Access Compliance Report Public Rights-of-Way (Curb Ramps)

Main Street: N/A Cross Street: TERRACE_RD Location: E

ADA ID: RPRK211110113246 Ramp Type: Type 4 - Parallel Initial Pass/Fail: Fail Overall Compliance: No Severity Score: 2

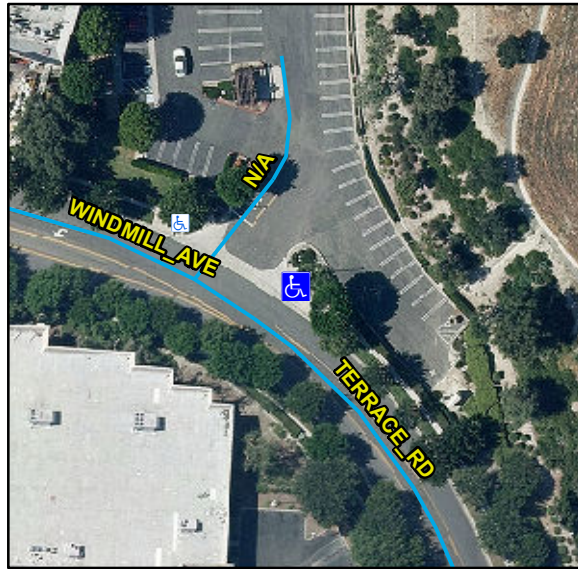
Compliance	Description	Data	Compliance	Description	Data
N/A	Ramp Length LT (in)	140	N/A	Ramp Length RT (in)	138
Yes	Ramp Width LT (in)	89	Yes	Ramp Width RT (in)	89
Yes	Ramp Run Slope LT (%)	3.5	Yes	Ramp Run Slope RT (%)	7.5
No	Ramp Cross Slope LT (%)	3	No	Ramp Cross Slope RT (%)	3.4
N/A	Landing Present	N/A	N/A	DWS Provided	N/A
N/A	Landing Length (in)	N/A	N/A	DWS Contrast	N/A
N/A	Landing Width (in)	N/A	N/A	DWS Length (in)	N/A
N/A	Landing Run Slope (%)	N/A	N/A	DWS Full Width	N/A
N/A	Landing Cross Slope (%)	N/A		DWS Offset Type	N/A
N/A	Landing Movement Obstructed?	N/A	N/A	DWS Offset Left (in)	N/A
	Landing Movement Type	N/A	N/A	DWS Offset Right (in)	N/A
N/A	Landing Shared	N/A			
N/A	Clear Space	Yes			
N/A	Clear Space To Crosswalk (in)	N/A			
N/A	Marked Crosswalk 1	No	N/A	Marked Crosswalk 2	No
	Crossing 1 Direction	NW		Crossing 2 Direction	SW
	Marked Crosswalk 1 Width (in)	N/A		Marked Crosswalk 2 Width (in)	N/A

Remove & Replace Curb Ramp With Two New Directional Ramps or Equivalent.

R204.3, R304.5.3, STD 1115
